City of Phoenix
PLANNING & DEVELOPMENT DEPARTMENT

ADDENDUM A
Staff Report: Z-SP-6-21-7
March 3, 2022

202 and Southern Storage

Preliminary Elevations

BLDG. A NORTH ELEVATION
 SCALE: 1/16" = 1'-0" - STREET VIEW

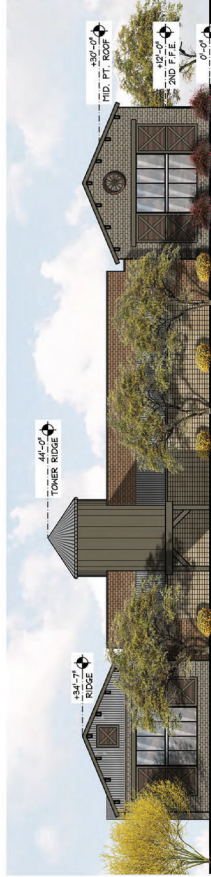
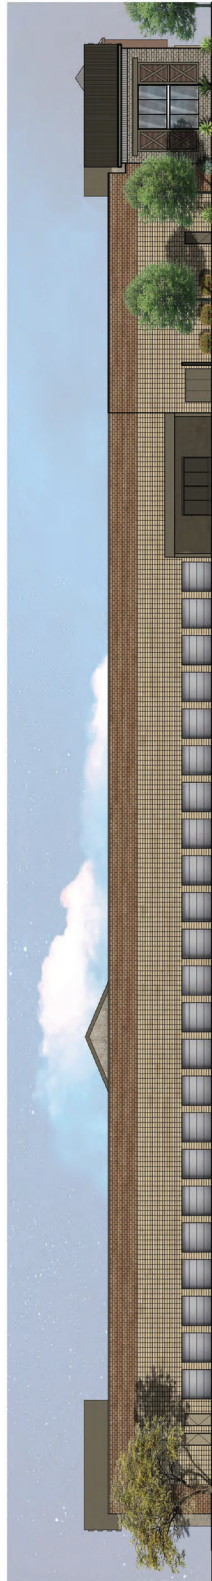
- a. ~~The north elevation OF BUILDING A, AND EAST ELEVATIONS OF BUILDINGS B AND C, AS DEPICTED ON THE SITE PLAN DATE STAMPED JANUARY 24, 2022,~~ shall incorporate windows along ~~the front façade.~~

- B. ~~THE NORTHWEST CORNER NORTH ELEVATION OF BUILDING A, AS DEPICTED ON THE SITE PLAN DATE STAMPED JANUARY 24, 2022,~~ SHALL INCORPORATE A DECORATIVE SILO.

BLDG. C NORTH ELEVATION
 SCALE: 1/8" = 3/8' STREET VIEW

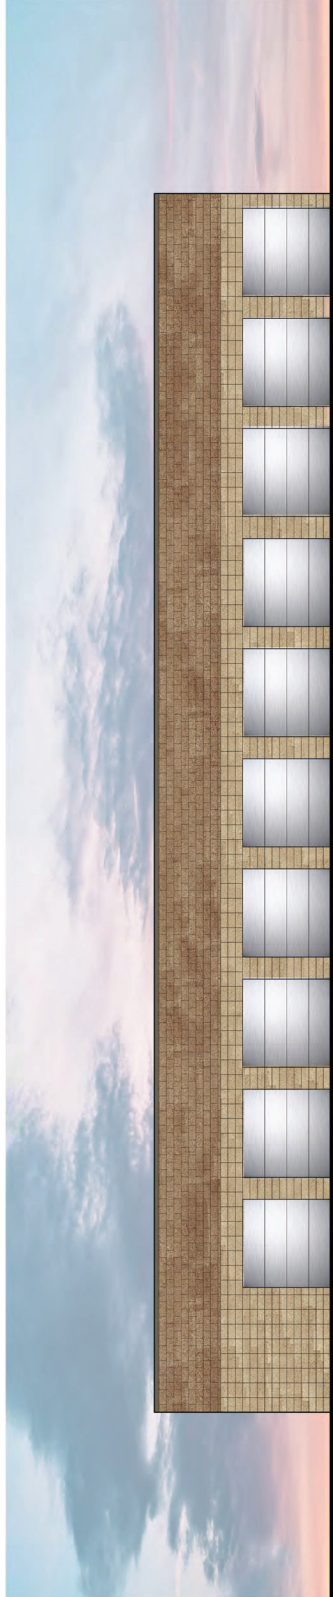
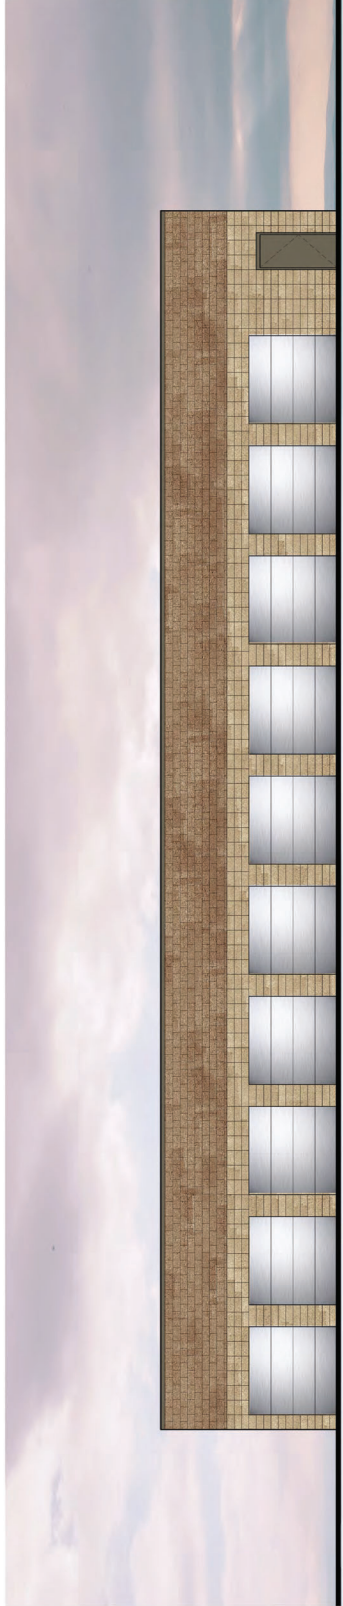
- b. C. ~~All building elevations shall contain architectural embellishments and detailing such as textural changes, pilasters, offsets, recesses, variation in window size and location, and/or overhang canopies.~~ **THE NORTH AND EAST ELEVATIONS OF BUILDING C SHALL INCORPORATE DECORATIVE ELEMENTS SUCH AS PITCHED ROOFS CONSISTENT WITH THE ELEVATIONS OF BUILDINGS A AND B.**
